ADDENDUM
NO. 1

July 27, 2026

MERRILLVILLE HS CULINARY AND MEETING AREA RENOVATIONS AND MERRILLVILLE CSC CENTRAL OFFICE ADDITION AND RENOVATION PROJECT

This Addendum consists of pages ADD 1-1 through ADD 1-5 and attached and attached Addendum No. 1 from Gibraltar Design dated July 24, 2026, and consisting of 8 pages, revised Specification Section 08 71 00 - Door Hardware and 47 Drawings.

DRAWING
UNIT "T" ARCHITECTURAL FIRST FLOOR DEMOLITION PLAN

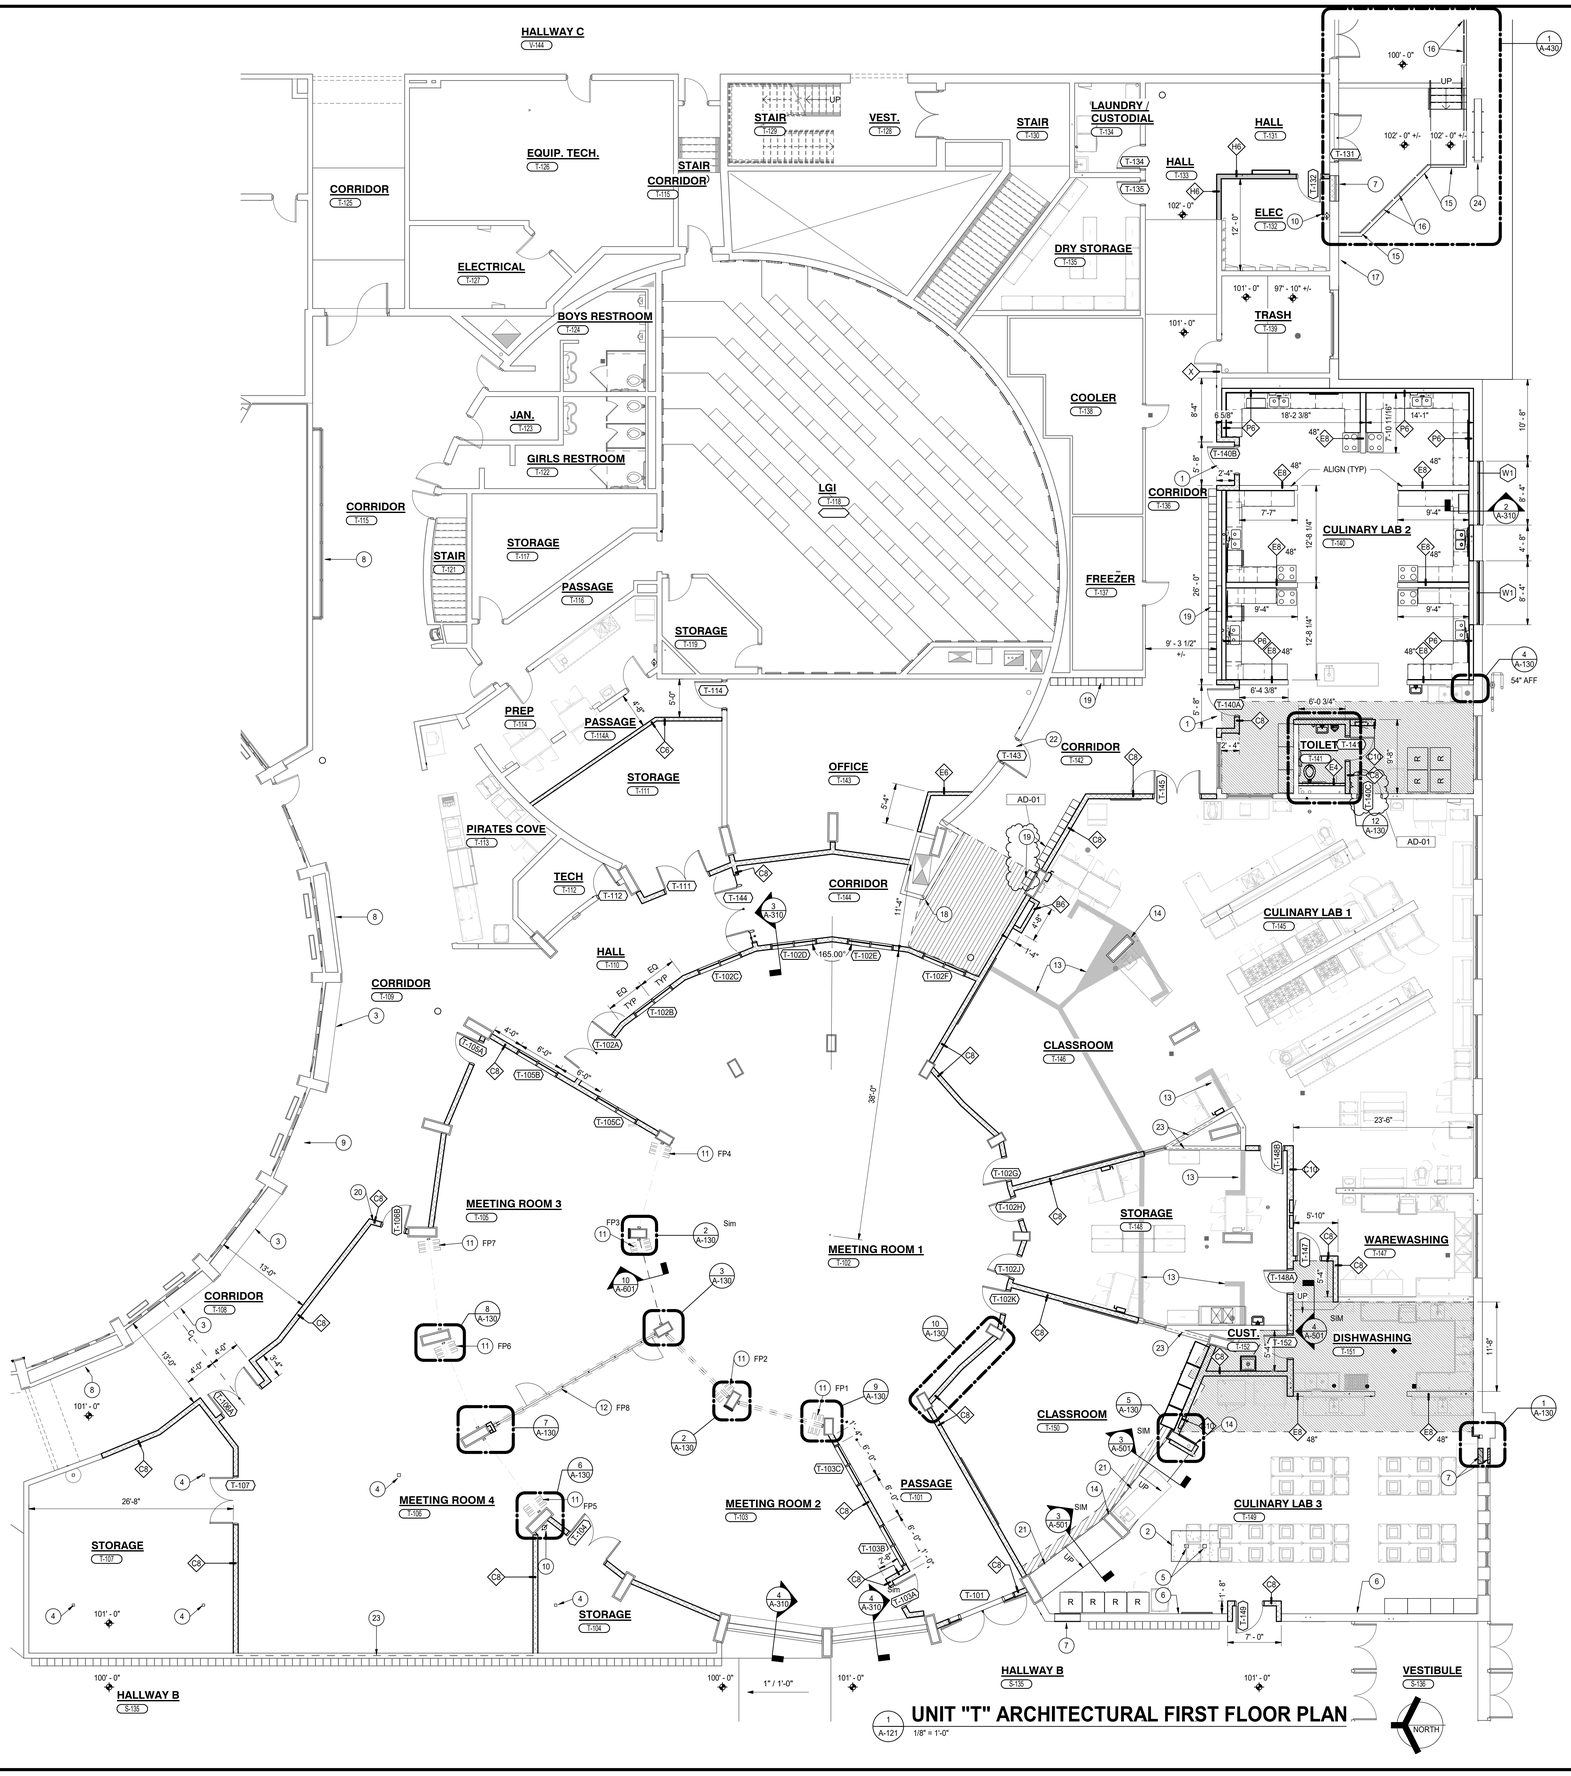
8. Sheet AD121

1. Repair quarry tile wall base in room Office T-143. See plan for locations.
2. Replacement of door to Kitchen ET-106 from Passage ET-121.
3. Replacement of door to Cook's lounge ET-107 from Kitchen ET-107

1 A-310 **SOUTH ELEVATION**
1/4" = 1'-0"

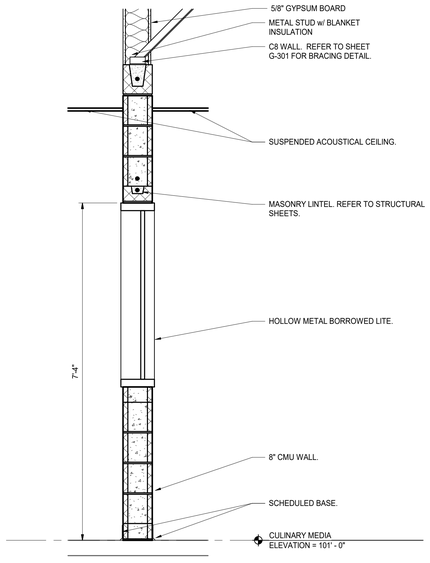
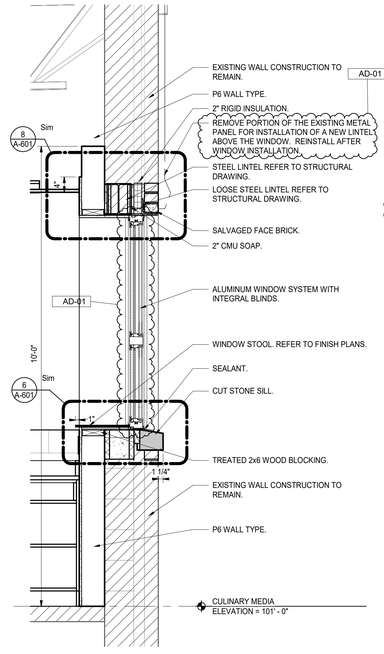
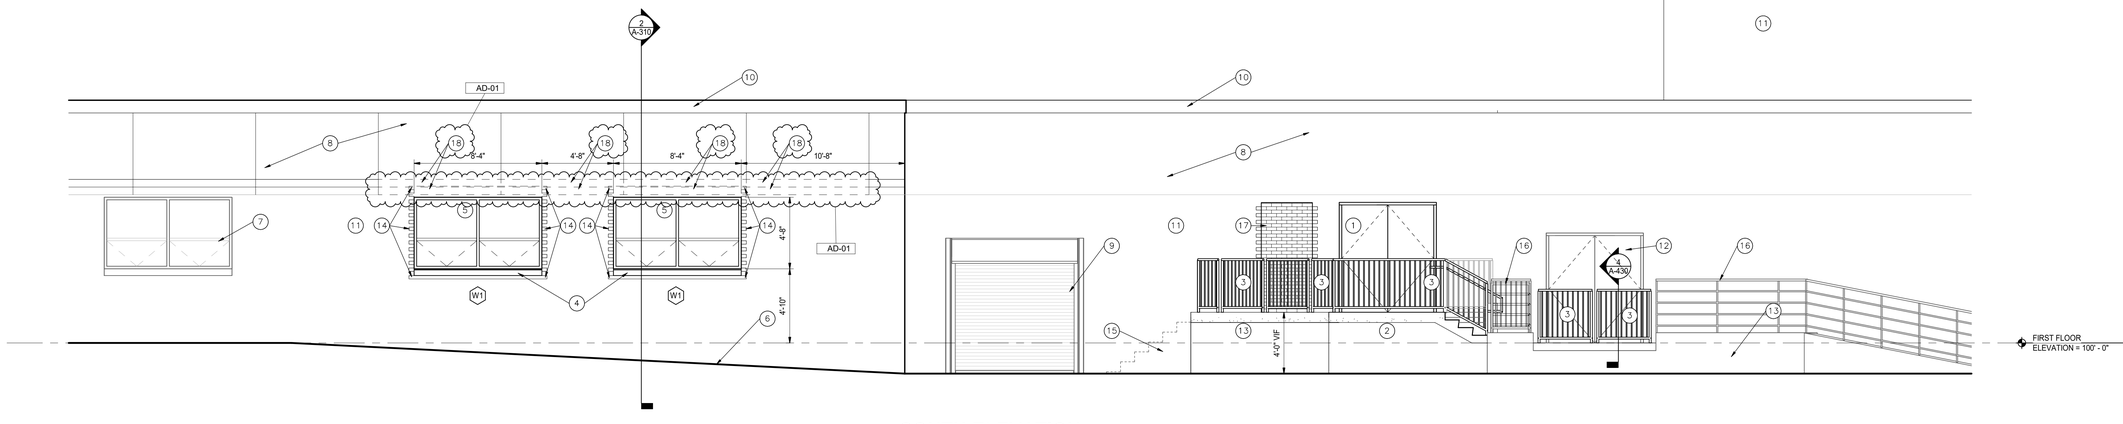
10. Sheet A-310

a. Added notes to remove existing metal panel for installation of window.
b. Updated graphic showing integral blinds in window.

DRAWING
TYPICAL DETAILS

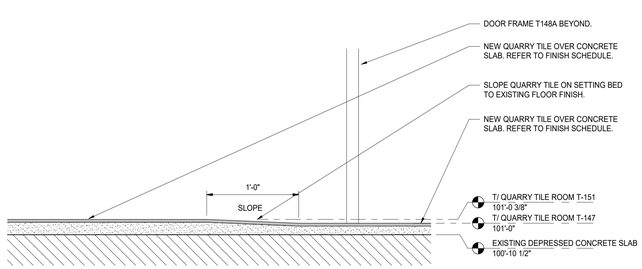
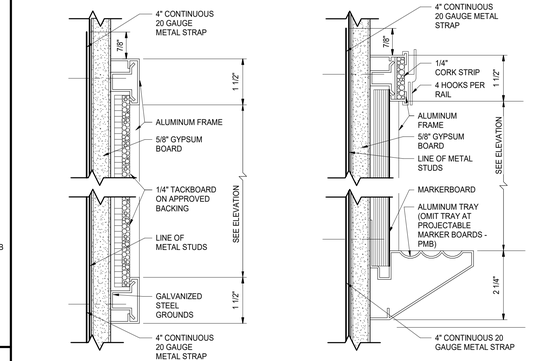
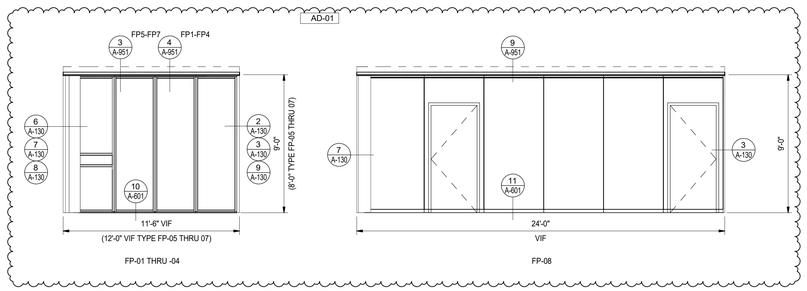
11. Sheet A-501

DRAWING
DOOR SCHEDULE, FRAME PROFILES, ELEVATIONS AND DETAILS

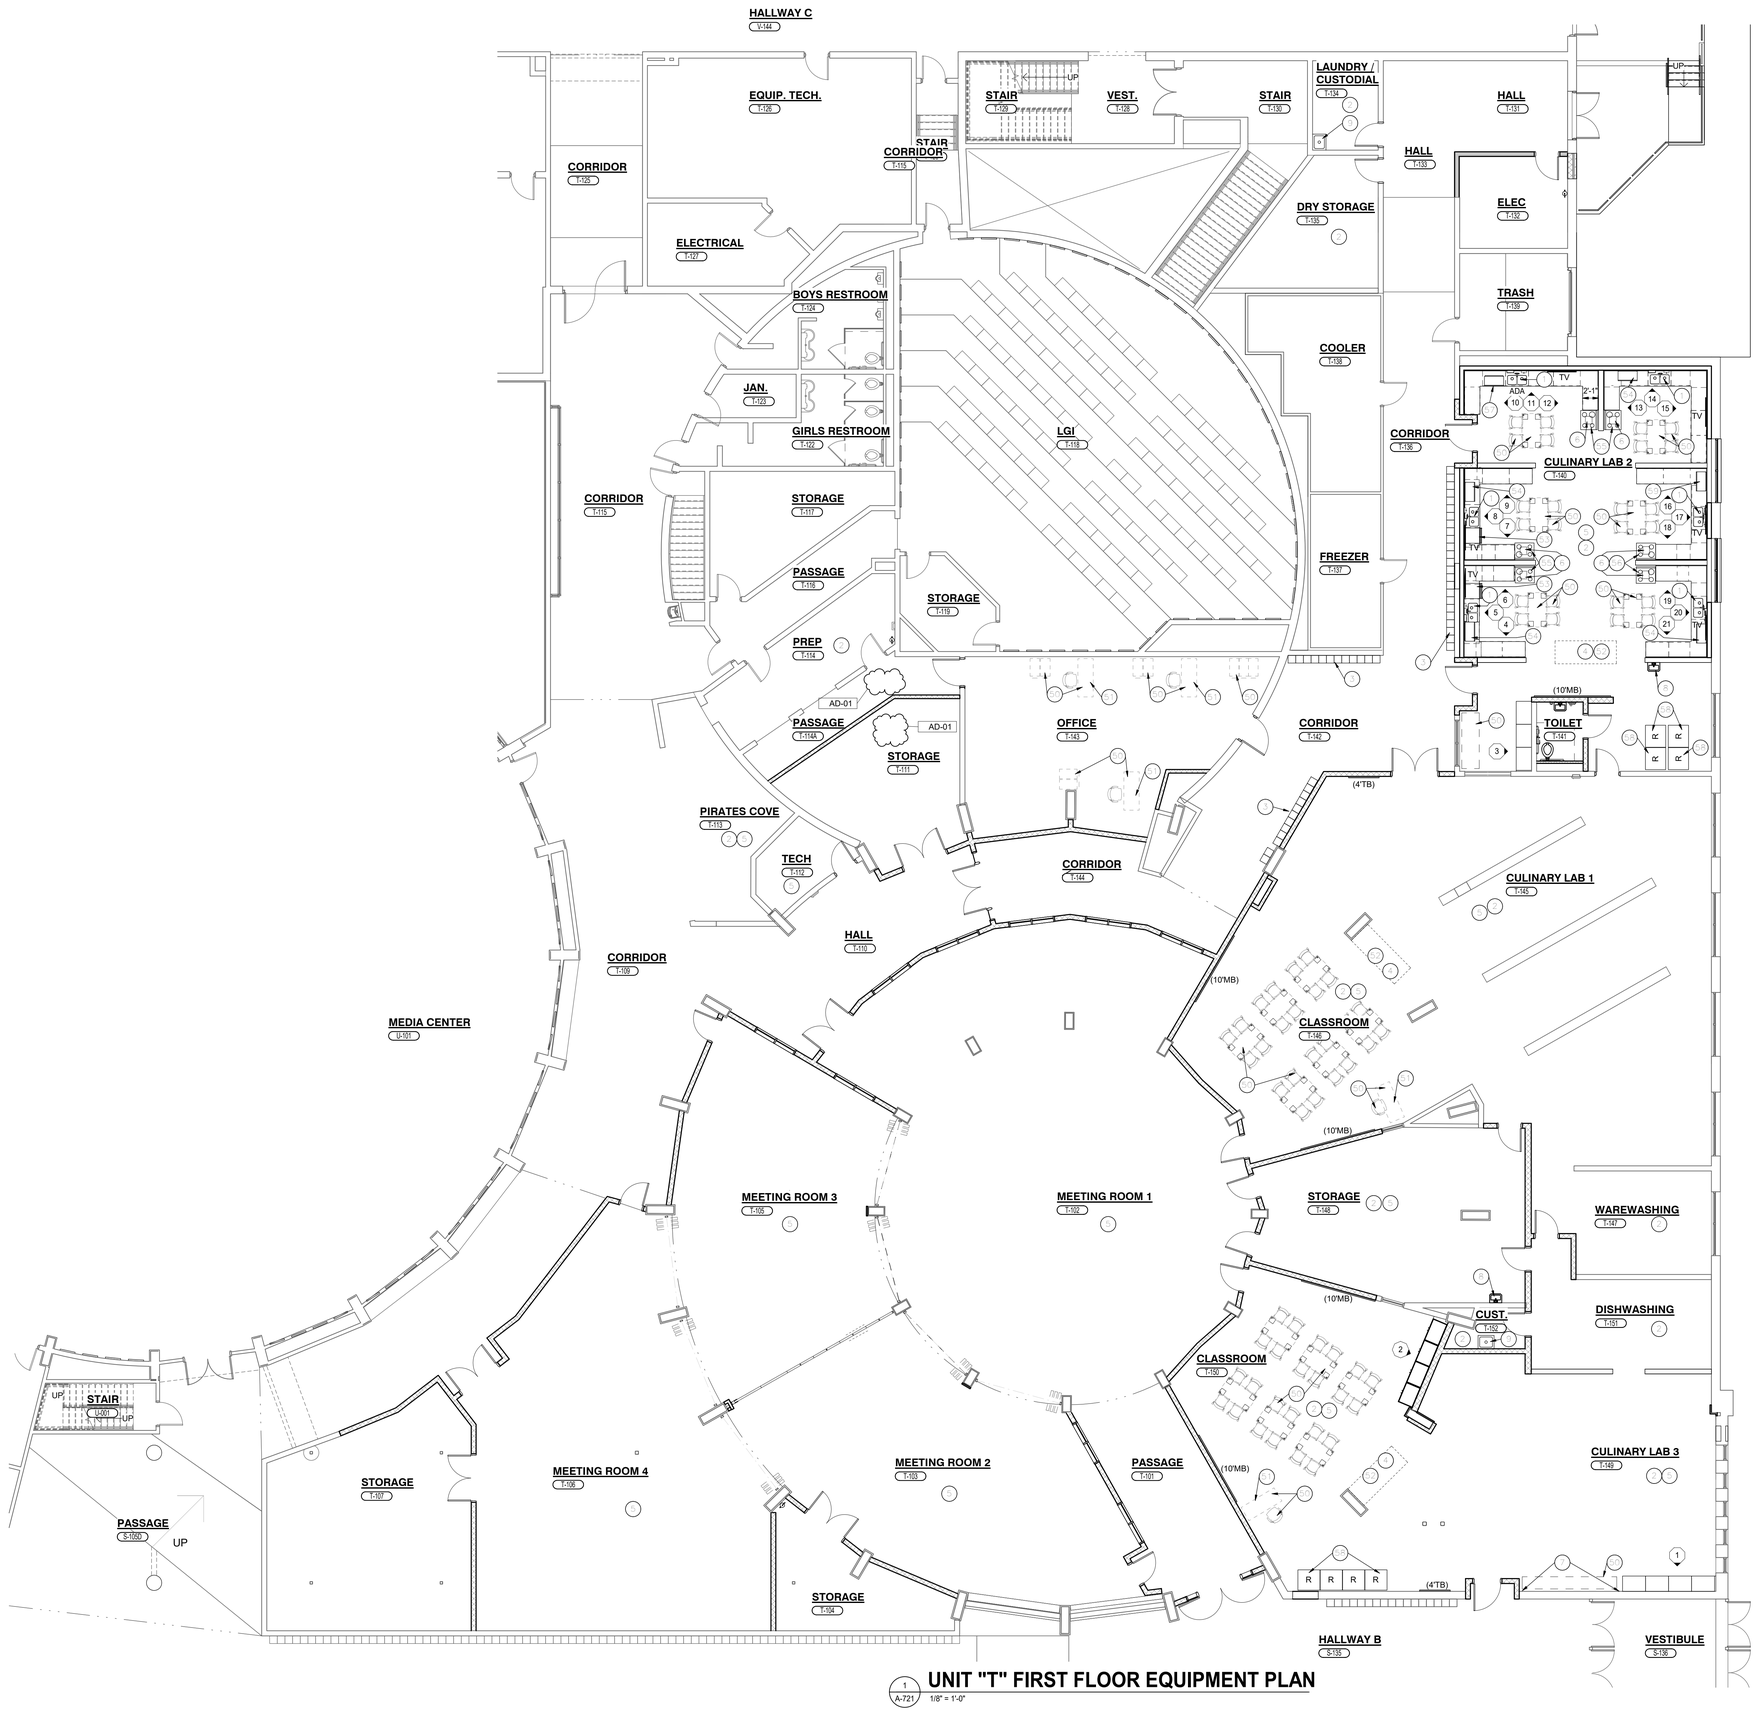
12. Sheet A-601

a. Omitted detail 13/A-601.
b. Added callouts to Folding Partition Legend 12/A-601.
c. Added callouts to Aluminum Window Legend 9/A-601.
d. Revised Door and Frame Schedule.

DRAWING
UNIT "T" FIRST FLOOR EQUIPMENT PLAN

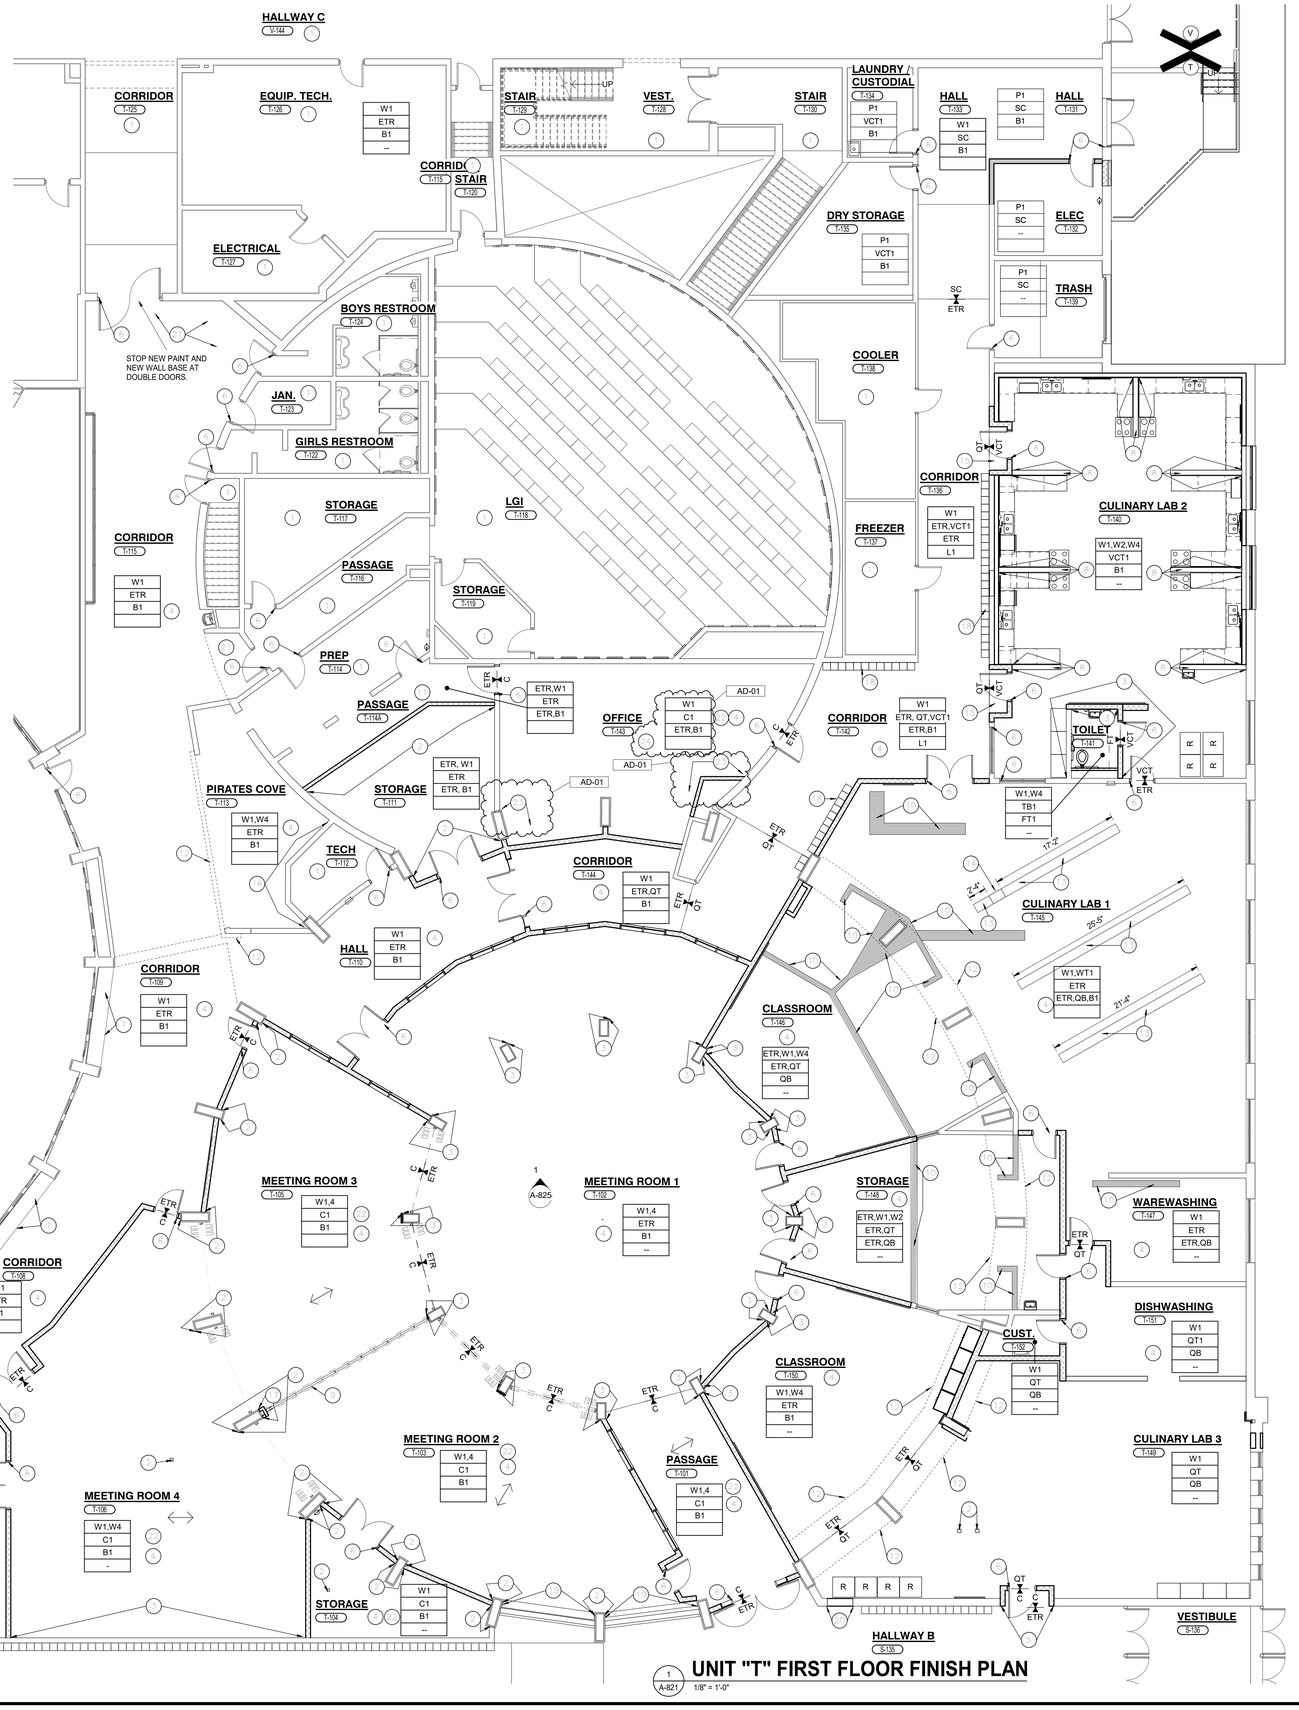
13. Sheet A-721

A. Refer to revised, full-size drawing, included in this Addendum, for revisions.
   1. Omitted wall protection in Storage T-111 and Passage T-114A.
